SERVICE BULLETIN

APPLICABILITY: 2015-2017MY Legacy and Outback
2015-2017MY WRX

NUMBER: 04-17-17R

SUBJECT: Rattling Sound from EPS Gear Box

Lot Number Identification:

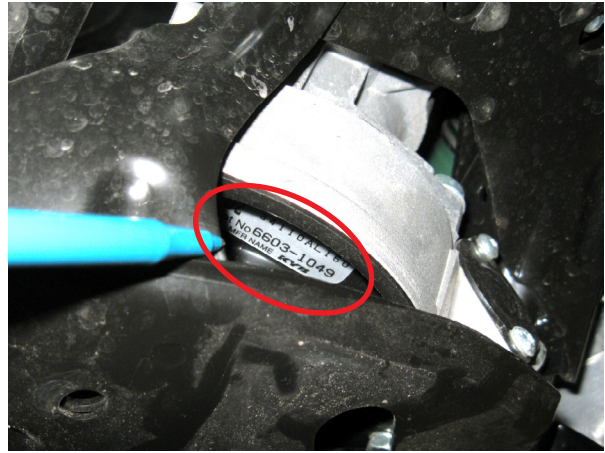
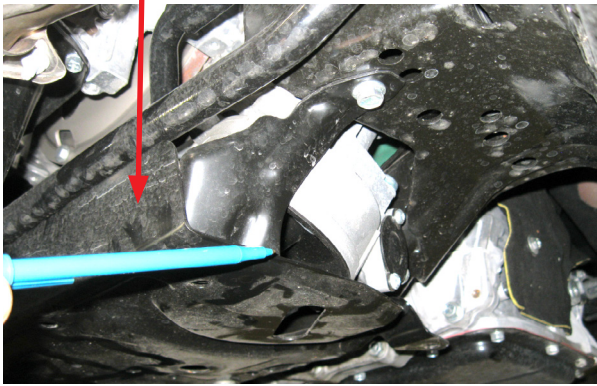
VERY IMPORTANT: These 4 digits determine the EPS **gear box** Lot Number (date code).

- The first number (a 6 in the picture) is the year (2016).
- The second (also a 6 in the picture) indicates the 6th month (June).
- The third and fourth (03 in the picture) is the 3rd day (June 3, 2016)
- The second set of 4 numbers (1049) is the production number or serial number for that specific date.

If the Lot Number is **equal to or after 7421 (April 21, 2017)**, the EPS **gear box** is post-countermeasure and the condition **will not be repaired** by replacing the tension spring.

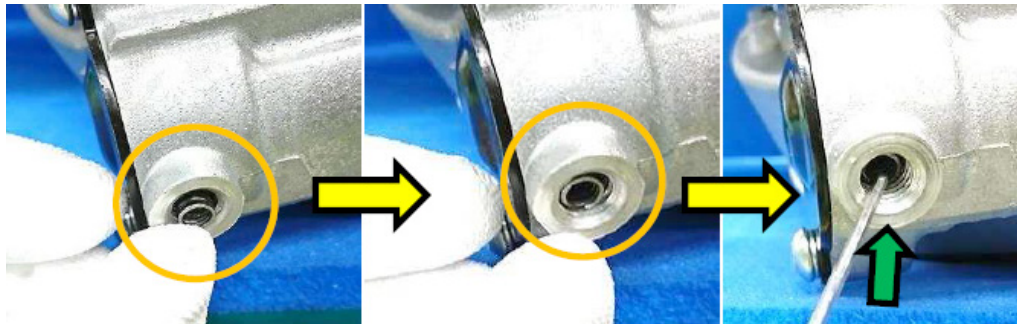
Step 2- Using the special tool bit, remove the tension spring cover screw.

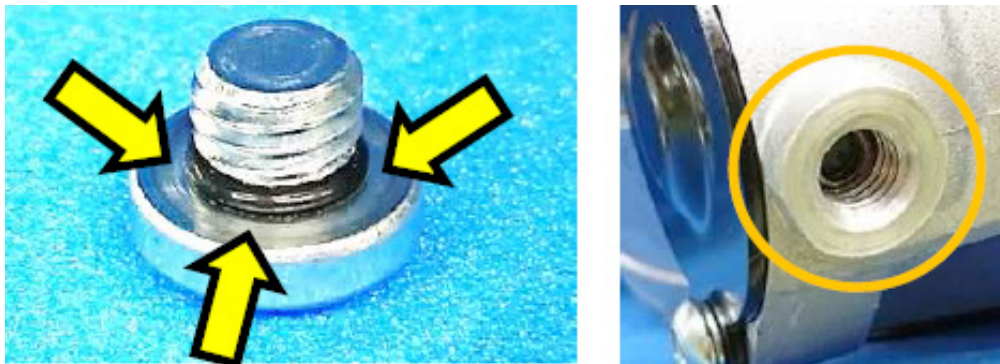
Step 3- Remove the tension spring and replace with the new part. Make sure the new spring is fully seated in the hole.

EPS GEARBOX BACKLASH ADJUSTING PROCEDURE:

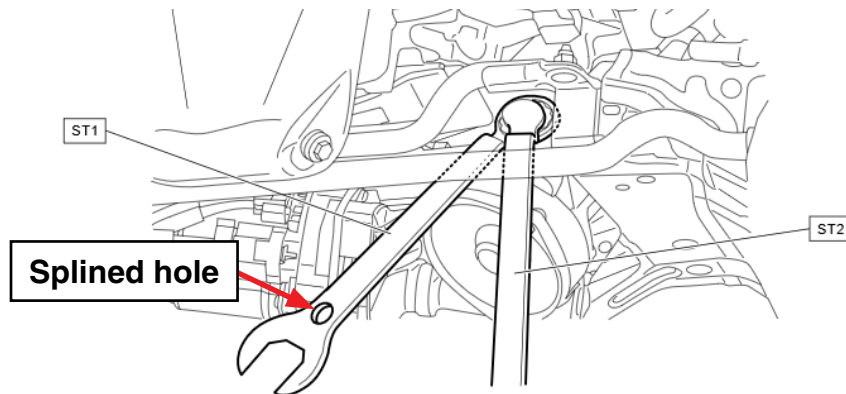
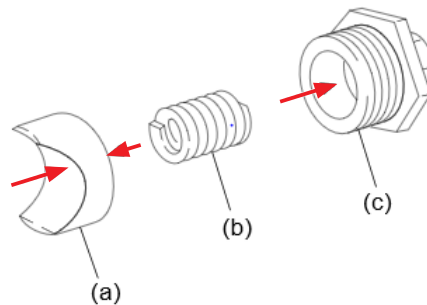
- Front under-cover
- Front Stabilizer bar
- Front exhaust pipe assembly
- 5 bolts securing the TPS rack guard as shown.

- 2) Use the special tools to loosen / remove the lock and adjusting nut (c), spring (b) and pressure pad (a).
